**DM/26/01835 - Gatehouse Hub, Goddards Green**

I refer to the above application, currently pending determination by the Local Planning Authority, and specifically to the comments received from the West Sussex County Council Highways Authority dated 2nd October 2026.

Figure 1: Extract of approved site layout (DM/25/3125)

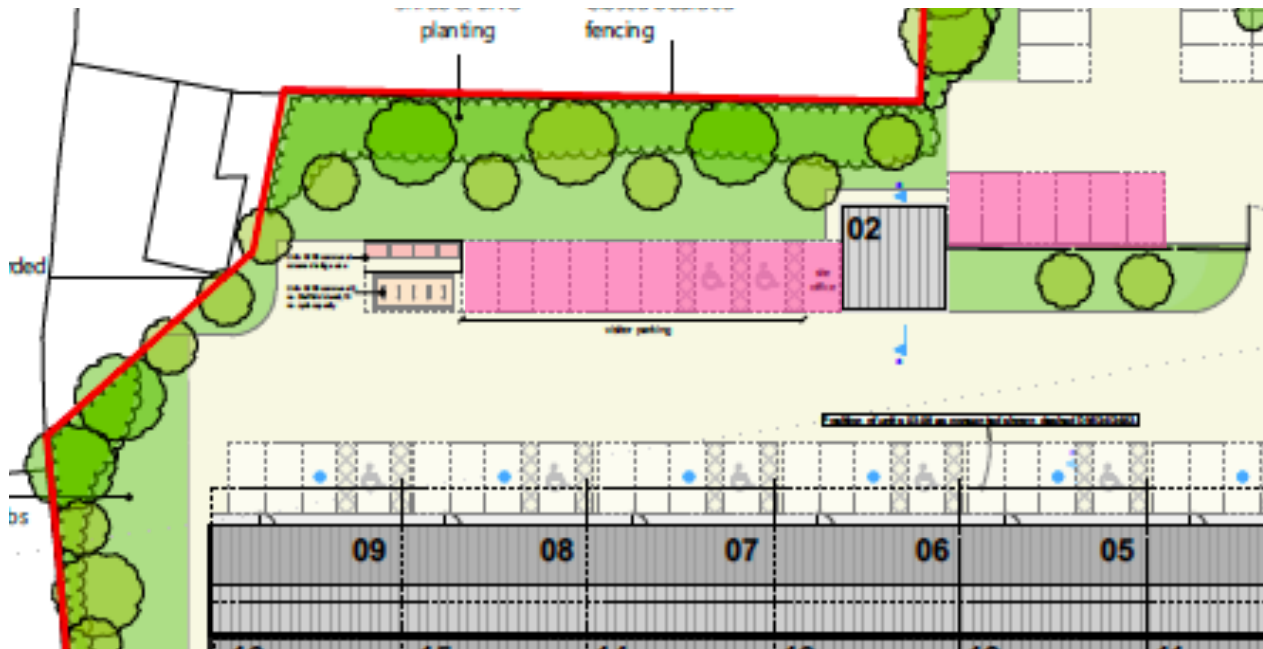
Whilst the Highway Authority raises no in-principle objection to the use of the existing access arrangements or the modest increase in traffic that may be generated by the proposed additional commercial floorspace, further information has been requested regarding parking provision across the wider Gatehouse Hub development. Specifically, clarification has been sought in relation to:

- The total number of vehicle parking spaces approved across the wider Gatehouse Hub development;
- The number of standard, visitor and accessible parking spaces forming part of that approved provision;
- The number and type of parking spaces that would be displaced or otherwise affected by the current proposals;
- The 12 spaces proposed specifically to serve the additional pod units;
- The resultant total number of standard, visitor and accessible parking spaces across the wider development following implementation of the proposals and;
- An assessment demonstrating that the resultant parking provision is appropriate for the development as a whole, including the additional commercial floorspace, having regard to the applicable WSCC parking guidance.

Importantly, the proposal does **not** result in the loss of any approved parking spaces. Instead, a number of approved spaces are simply relocated to accommodate the revised layout. The same is true for the approved cycle parking spaces. These are simply relocated within the site.

Figure 1 identifies the approved parking spaces affected by the proposals, whilst Figure 2 illustrates their proposed relocation.
